Product Change Notification / RMES-17GUBB791

CCB 4991 Final Notice: Qualification of MTAI as an additional Scan/Pack process site and implement packing changes for selected products available in 32L PLCC (11.5x14x3.37mm) package.

Description of Change: Qualification of MTAI as an additional Scan/Pack process site and implement packing changes for selected products available in 32L PLCC (11.5x14x3.37mm) package.

Pre and Post Change Summary – Pin 1 Orientation

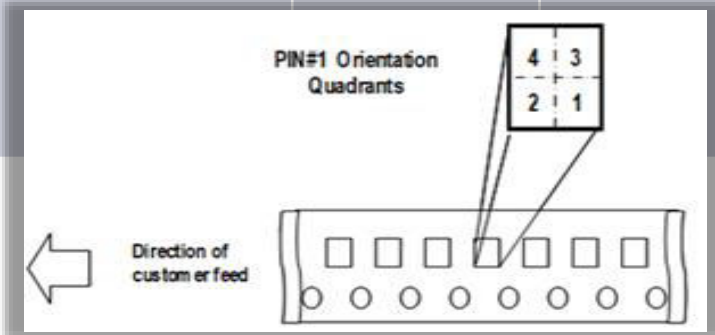
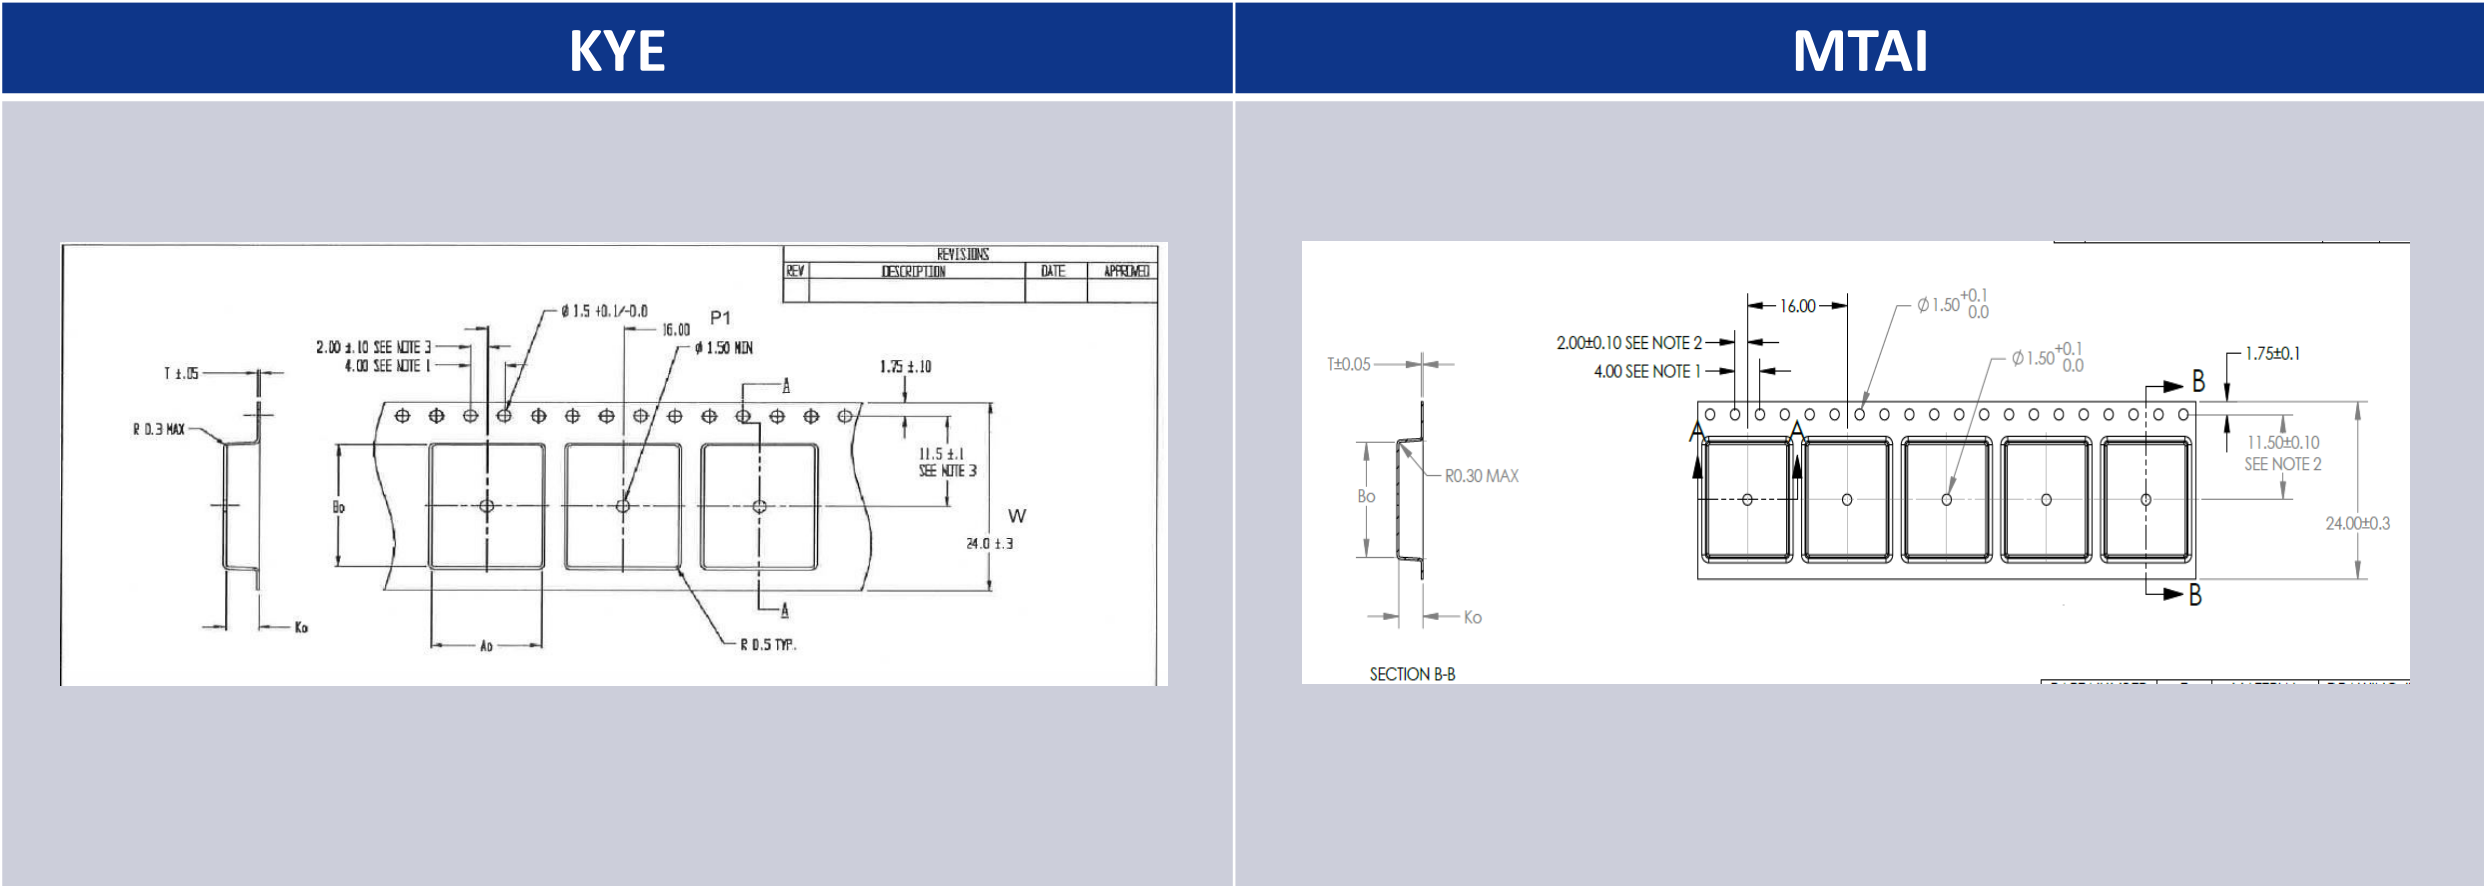
KYE	MTAI
Pin 1 Orientation	Tape and Reel	 Diagram showing the KYE Pin 1 Orientation. It features two square components with pin grids, each with a small black dot indicating the Pin 1 location. Below the components is a row of seven circles representing the carrier tape. The components are oriented such that their Pin 1 dots align with the first two circles of the carrier tape.	 Diagram showing the MTAI Pin 1 Orientation. It features two square components with pin grids, each with a small black dot indicating the Pin 1 location. Below the components is a row of seven circles representing the carrier tape. The components are oriented such that their Pin 1 dots align with the first two circles of the carrier tape.
		Quadrant 1- 2	Quadrant 1- 2

Pre and Post Change Summary – Cover Tape

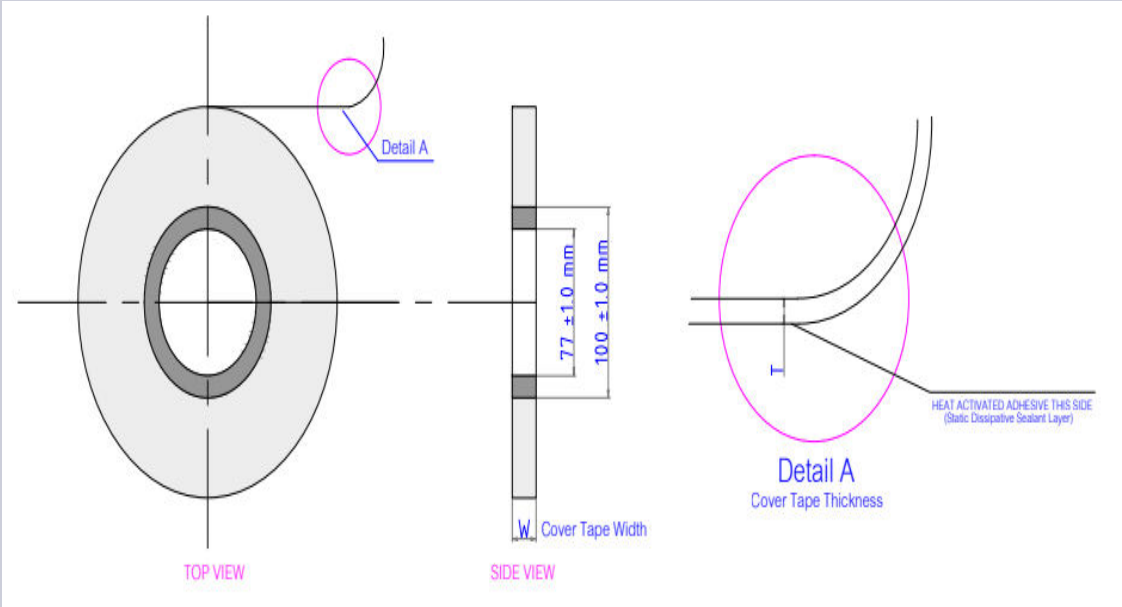
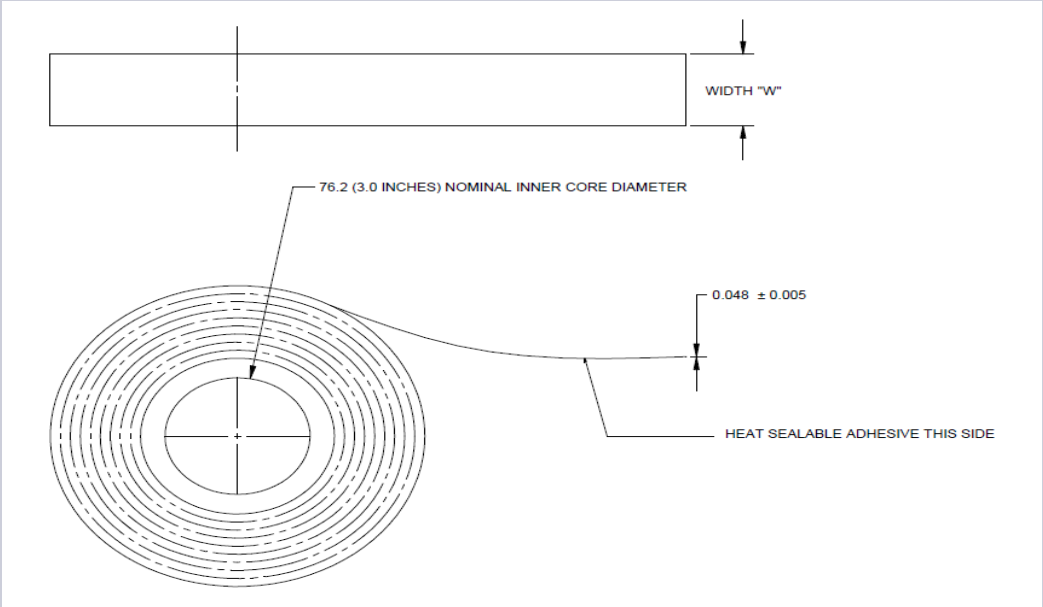
Cover tape color	Width ± 0.1 (mm)	Thickness ± 0.005 (mm)	Sealing Methodology
Transparent	21.3 ± 0.1	0.048 ± 0.005	Heat Seal

Cover tape color	Width ± 0.1 (mm)	Thickness ± 0.005 (mm)	Sealing Methodology
Clear	21.0 ± 0.1	0.050 ± 0.010	Heat Seal

Pre and Post Change Summary – Plastic Reel

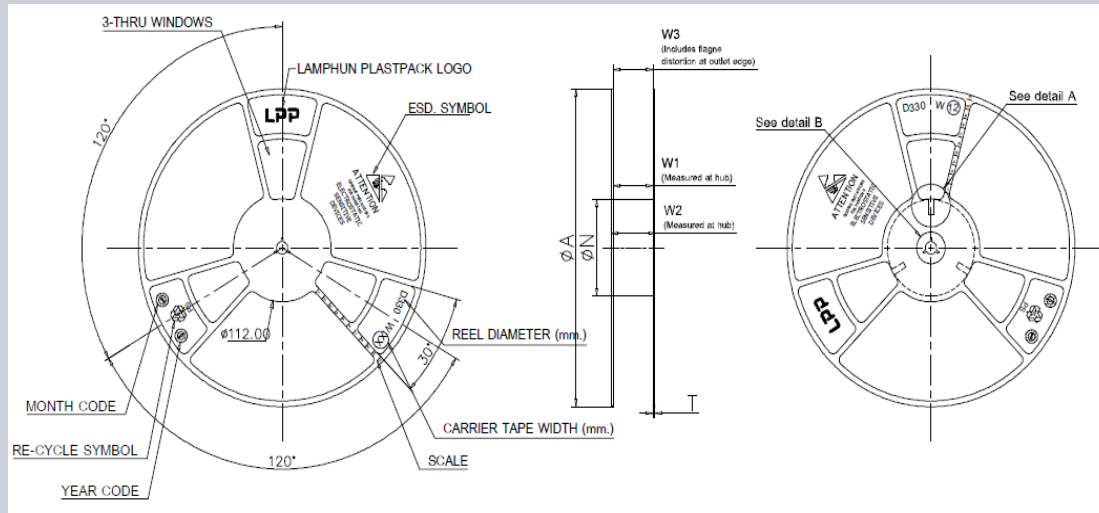
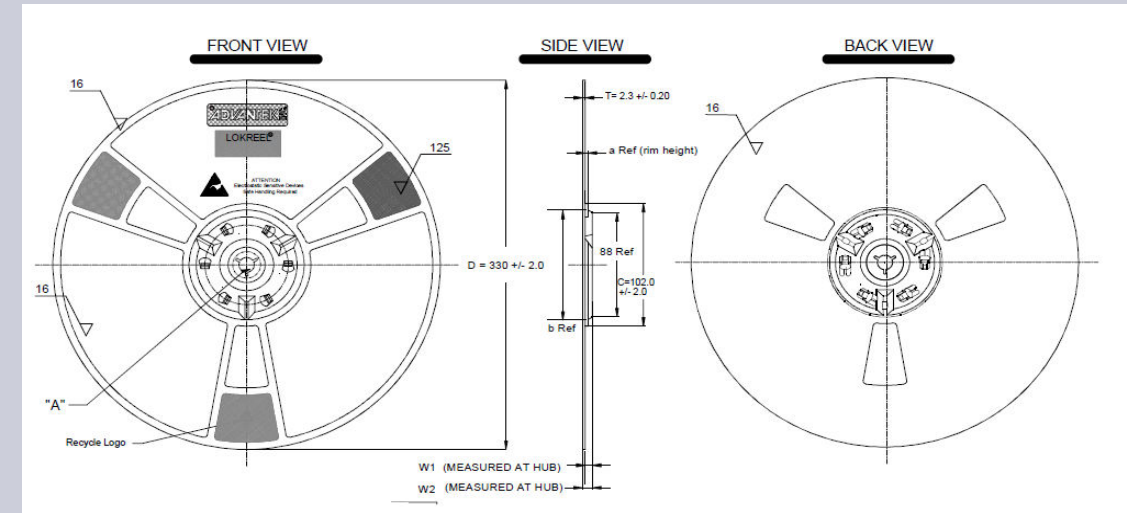
Reel Color	Reel diameter (mm)	Hub (mm)	Reel Width Max (mm.)
Regrind Blue	330 ±2.0	102±2.0	8.4 + 16.4

Reel Color	Reel diameter (mm)	Hub (mm)	Reel Width Max (mm.)
Dark Blue	330 ±2.0	100 ±2.0	30.40

Packing Method – Tape and Reel

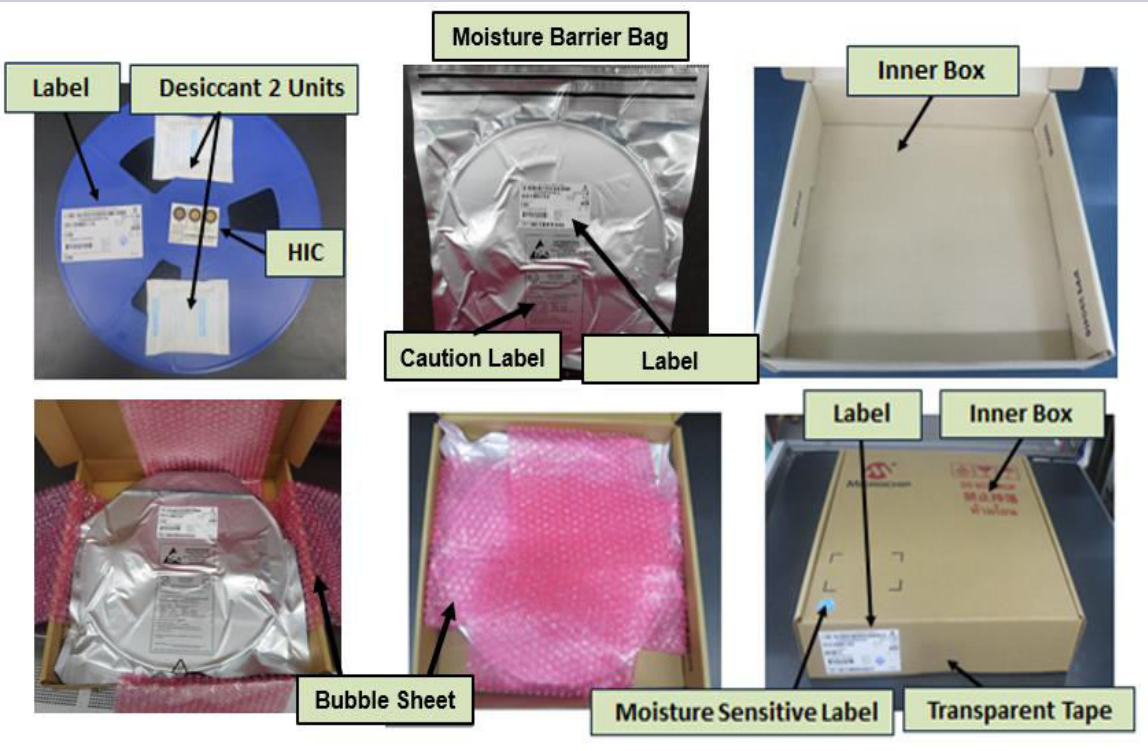
KYE

MTAI

Pre and Post Change Summary – Tube Dimension

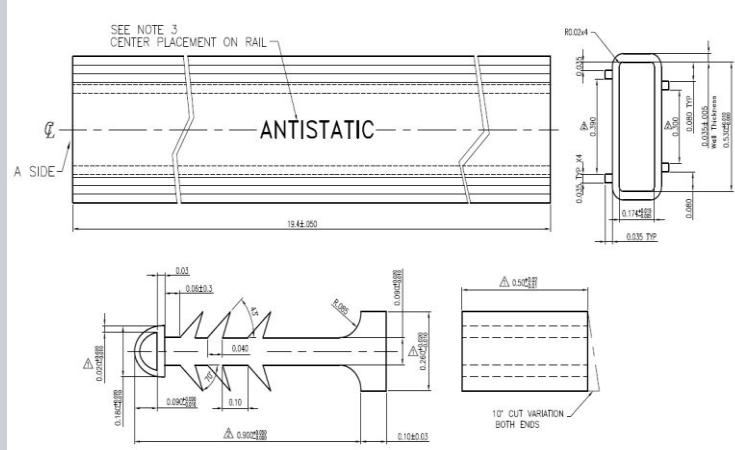
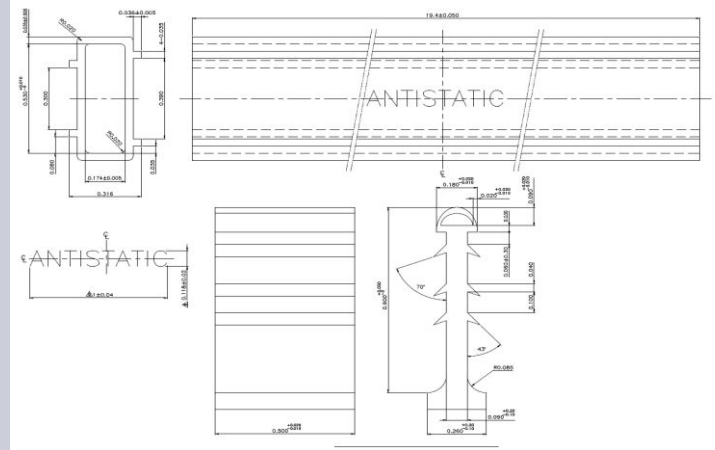
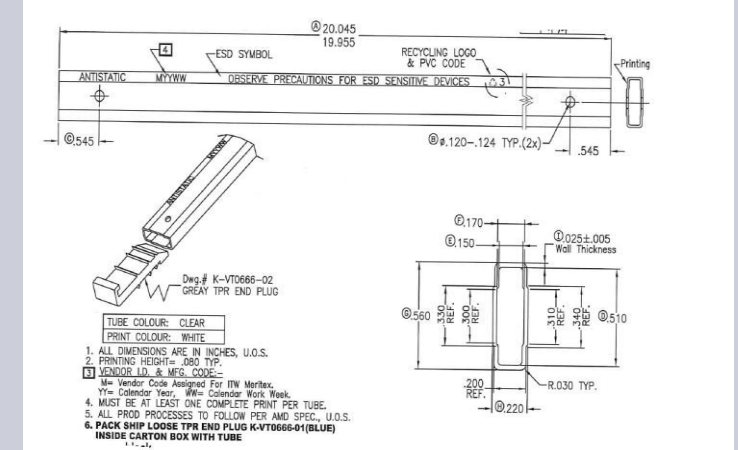
Tube	Scan / Pack Site	Tube Length (in)	Dimension A (in)	Dimension B (in)	Tube Color
MMT	KYE, MTAI	20.045	0.510	0.150	Clear
LPI	KYE	19.4	0.53	0.174	Clear
GTK	KYE	19.4	0.53	0.174	Clear
